User Safety Notice

50 ft. / 15 m. Workman® Self-Retracting Lanyard

October 28, 2015

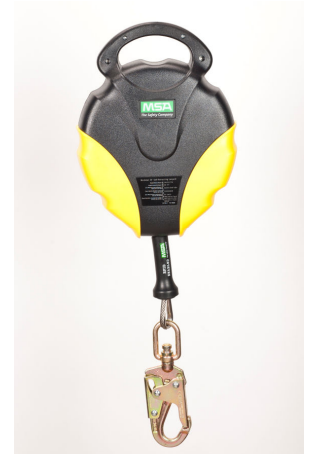
We have determined that a small percentage of Workman 50 ft. / 15 m. SRLs manufactured from January through August of 2015 may have an improper brake nut torque setting. This condition is not detectable when performing the normal pre-use inspection procedure. SRLs with this condition may not arrest a user's fall or may not arrest it within the specified maximum arrest distance.

To identify affected 50 ft. / 15 m. Workman SRLs, check the label affixed to the unit. Affected SRLs have one of the following "model" numbers and the "date made" is from 01-2015 through 08-2015:

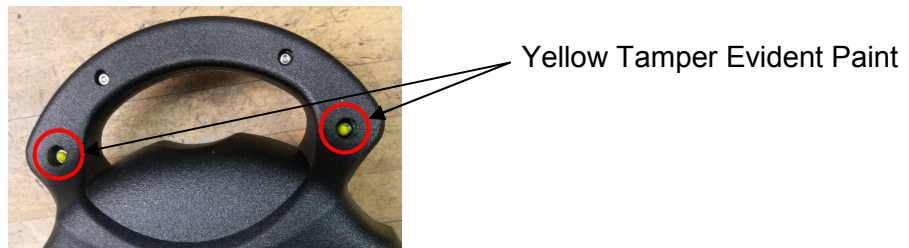
Please note that the replacement SRLs may also have a “date made” from 01-2015 through 08-2015, but include yellow tamper evident paint on the exterior housing screw heads near the handle, as shown in the photo below. These SRLs are new units that were factory upgraded to include a new brake assembly and are acceptable for use.
